NUCLEAR ENERGY INSTITUTE

Limerick Generating Station, Units 1 and 2  
Docket Nos. 50-352 and 50-353

**Proposed Technical Specifications Change to Relocate Surveillance Test  
Intervals to a Licensee-Controlled Program (Risk-Informed Initiative 5b)**

**DRAFT**  
**RESPONSE TO REQUEST FOR ADDITIONAL INFORMATION ON DRAFT NEI-04-10**  
**(METHODOLOGY DOCUMENT FOR RISK-INFORMED INITIATIVE 5B)**

**Figure 1**  
**Tech Spec Initiative 5 B Process**

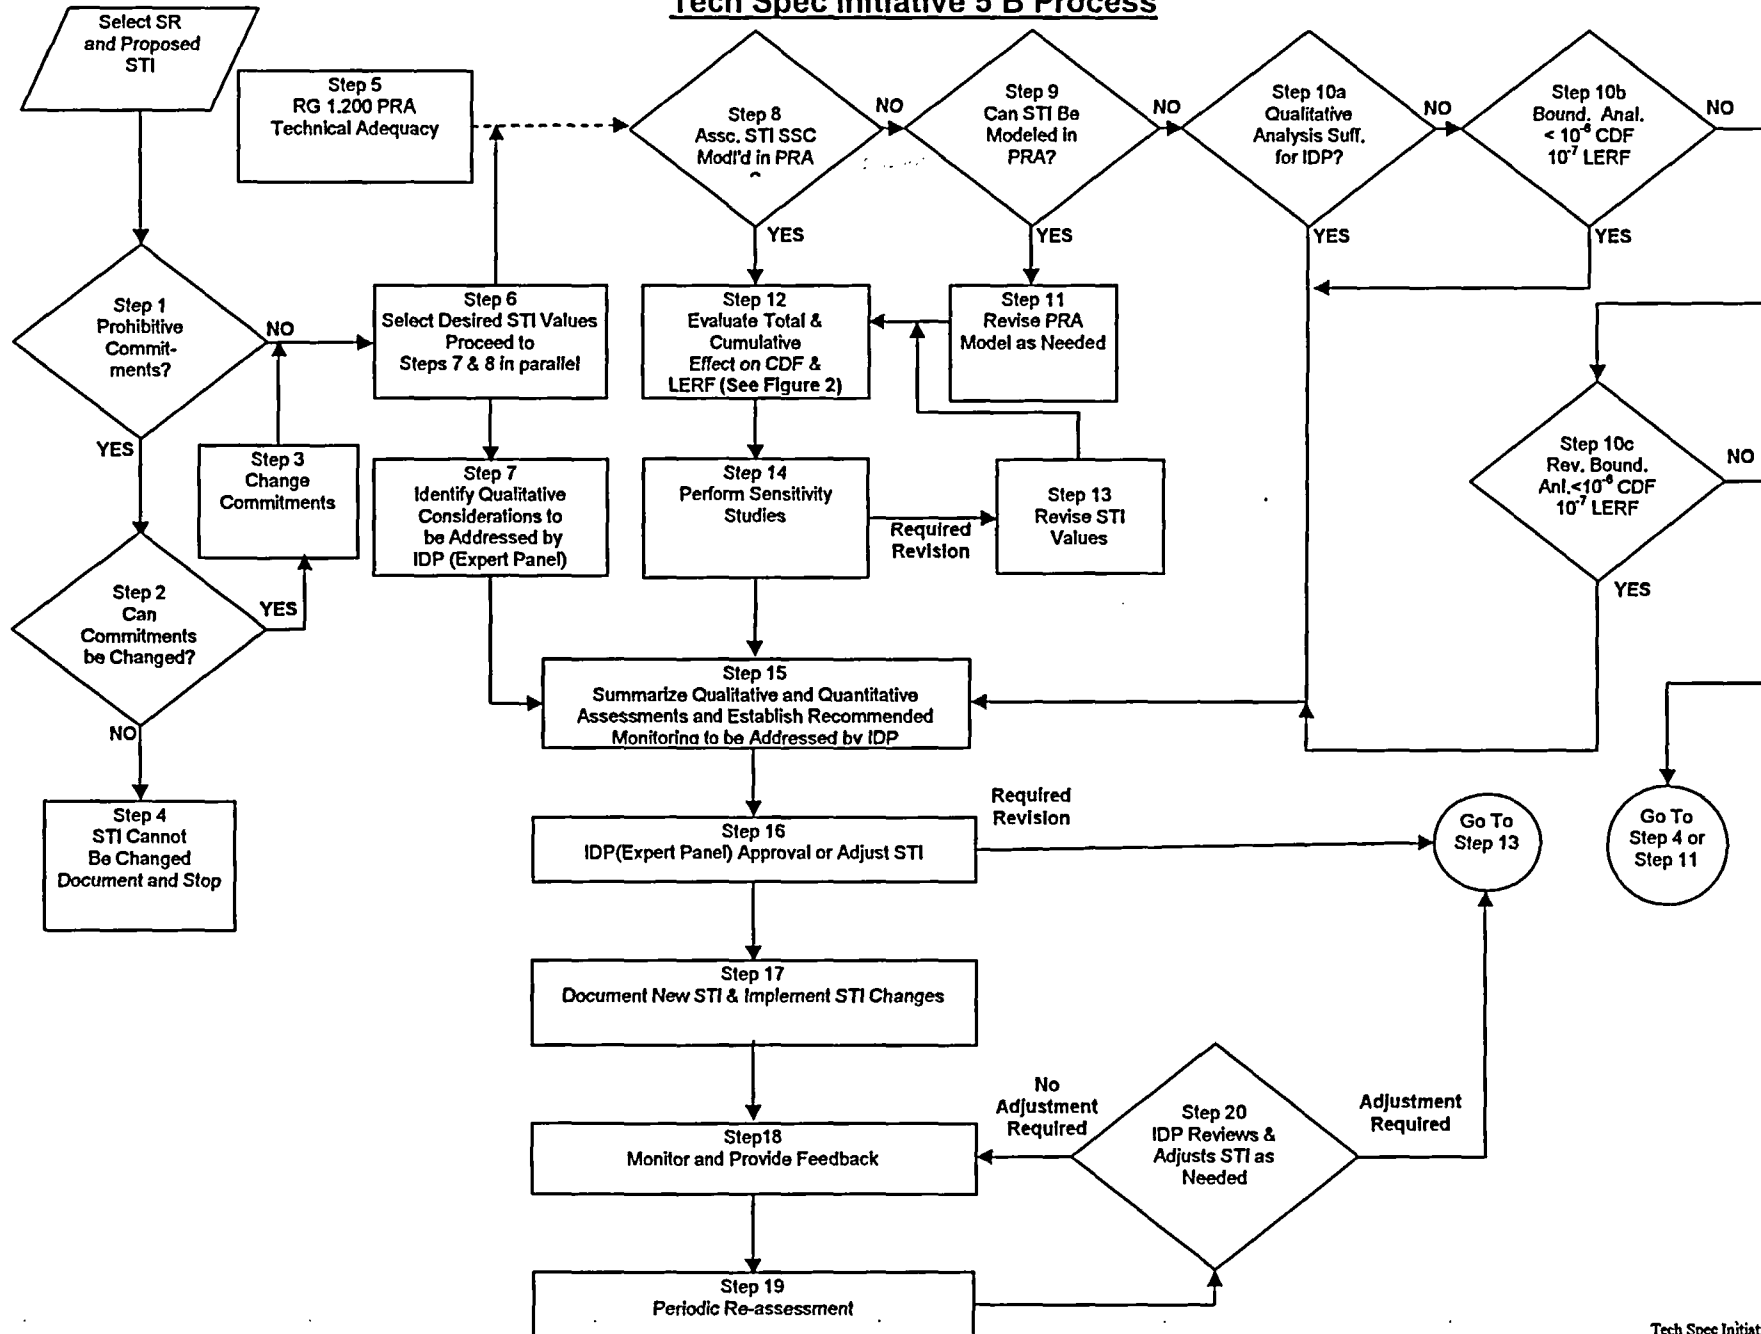
- a.  
Step 8 (NEI 00-04 Categorization) of Figure 1 is confusing. Step 8 should be a decision block, like Step 6, with outputs to both Step 9 (for those SSCs which the

Maintenance Rule process has categorized as LSSC and the NEI 00-04 process did not change the categorization and for those SSCs which the Maintenance Rule process has categorized as HSSC but the licensee used, successfully, the NEI 00-04 process to re-categorize to LSSC) and to Step 12 (for those SSCs which the Maintenance Rule process has categorized as LSSC but the NEI 00-04 process changed the categorization to HSSC and for those SSCs which the Maintenance Rule process has categorized as HSSC but the licensee used, unsuccessfully, the NEI 00-04 process to re-categorize to LSSC).

d. In the description of Step 9 it is stated that qualitative considerations are developed as an input to the Expert Panel. However, in Figure 1, it is stated that the Expert Panel identifies the qualitative considerations to be addressed. Please clarify.

c. In Step 27 (IDP Reviews Experience Results) it is stated that any changes identified by the IDP are routed to Step 24 (Monitoring and Feedback). This loop appears to mask the potential need to revise (downwards) an extended STI to address performance issues established by the monitoring program. Please clarify.

Separate paths for the treatment of HSSC and LSSC will be eliminated. Specifically, Steps 5 through 11 (except Step 7) in Figure 1 will be deleted. A new step (Step 15) will be added for System Engineering Assessment to determine appropriate monitoring requirements (existing Maintenance Rule (MR) monitoring or any other additional monitoring) based on the SSC risk significance. This should eliminate any confusion related to the treatment of HSSCs and LSSCs. See revised Figure 1 for more details.

The step "RG 1.200 PRA Technical Adequacy" will be revised to show a dotted line to Step 8 (Associated STI SSC Modeled in PRA?) in the revised Figure 1. With the corrections made to the figure, now it is clear that RG 1.200 is applicable to any PRA, internal, event, external events and shutdown, used in the evaluation. PRA standards for all external events and shutdown PRA are not yet endorsed by the RG 1.200, but when they are, the methodology would require conformance to the revised RG.

Figure 1 has been changed to reflect System Engineering input (Step 15) to the IDP (Step 16).

A new decision Step 20 has been added to the revised Figure 1 to provide either an adjustment required or no adjustment as determined by the IDP review. If an adjustment is required, the process goes back to PRA evaluation.

Step 27 has been replaced with the decision Step 20. Any changes identified by the IDP are routed to Step 13 (Revise STI Values), or if no adjustments are required are routed back to monitoring the results (Step 18).

**Figure 2**  
**Evaluation of Effect on CDF and LERF**

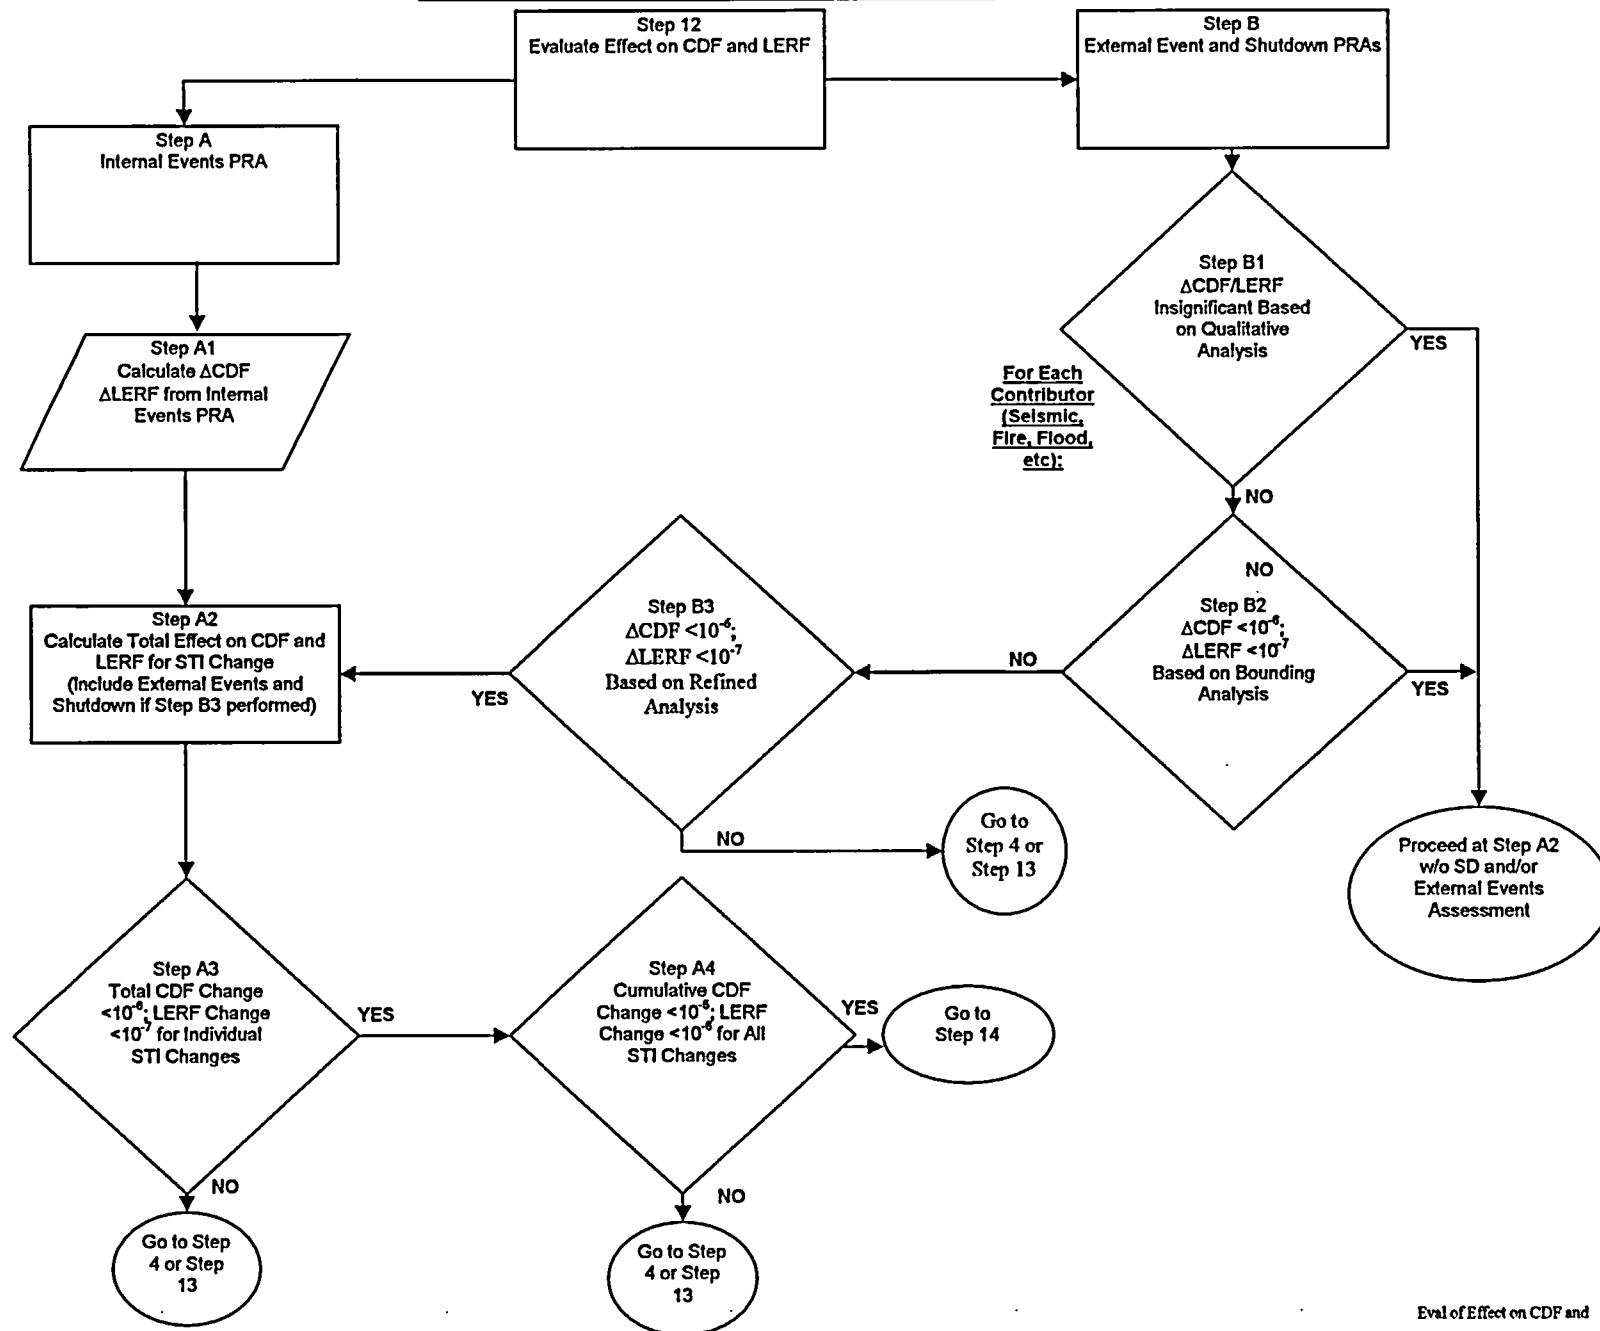
a. A more detailed description of Step 18 "Evaluate Cumulative Effect on CDF & LERF" is needed to make it clear what is meant and how are to be calculated the cumulative CDF and LERF changes associated with all STI extensions. Some questions that one can ask are: Are risk changes associated with STI extensions obtained by addition of all minimum cut set frequencies associated with both internal and external events at power and during shutdown operation? If this approach is approved and at a certain point in time a certain STI extension is considered, would the risk impact (i.e., the sum of the impacted minimum cut sets) include all revised unavailability values due to all STI extensions (i.e., both the one under consideration and all other previously implemented by using this approach)? What is an appropriate modification of common cause failure contributions in the minimum cut sets to reflect the new STIs? Will the impact of interactions among STIs be considered in calculating cumulative risk changes? Will the cumulative risk impact of STI extensions associated with both HSSC and LSSC be assessed and used in the decision making process? The answers to such questions need to be incorporated appropriately as guidance in the industry's methodology document.

b. The industry has often interpreted an increase in CDF of up to  $1 \text{ E-5/yr}$  and in LERF of up to  $1 \text{ E-6/yr}$  to be small and, therefore, acceptable. However, the guidance provided in RG 1.174 states that this is acceptable only when the plant's baseline risk from all sources (i.e., both internal and external events at power as well as during shutdown) has been reasonably assessed (i.e., uncertainties were also addressed) and is lower than  $1 \text{ E-4/yr}$ . Please confirm.

Step 12 has been revised to reflect the treatment of the total and accumulative effect on CDF and LERF (see new Figure 2). Two types of CDF/LERF changes are considered:

- 1) Step 12-A2 in Figure 2 covers the calculation of the total change on CDF/LERF for internal events, external events, and shutdown events.
- 2) Step 12-A4 in Figure 2 covers the integrated impact of any previously approved changes that must be factored into the cumulative change. That is, the cumulative change is calculated by including all previously revised unavailability values due to all STI extensions (not just the sum of the individual assessments). It should be noted that, Step 19 for periodic re-assessments now allows for a re-baselining of

Refer to the revised methodology discussion for Step 12 and Figure 2 (Evaluate the Total and Cumulative Effect on CDF and LERF). Unless screened by qualitative or bounding analysis, the sum of all risk increases from both internal and external events at power (as well as during shutdown) associated with all risk-informed STI extensions will be compared to the RG 1.174 limits for CDF and LERF.

Refer to the revised methodology discussion for Step 12 and Figure 2 (Evaluate the Total and Cumulative Effect on CDF and LERF). Specifically, refer to the methodology discussion for Step 12-A4 that includes the appropriate RG 1.174 guidance.

Refer to the revised methodology discussion for Step 12 and Figure 2 (Evaluate the Total and Cumulative Effect on CDF and LERF). Specifically, Step 12-A1 provides guidance indicating that CCF terms must also be included and adjusted for all components that are uniquely impacted by the STI change. Additionally, Step 14 (Perform Sensitivity Studies) clearly indicates that the CCF terms must also be changed for the initial sensitivity on the standby failure rates used in the base case STI assessment.

Guidance for integrating the impact of external events and events occurring during plant shutdown are included in the revised methodology discussion for Step 12 and Figure 2 (Evaluate the Total and Cumulative Effect on CDF and LERF).
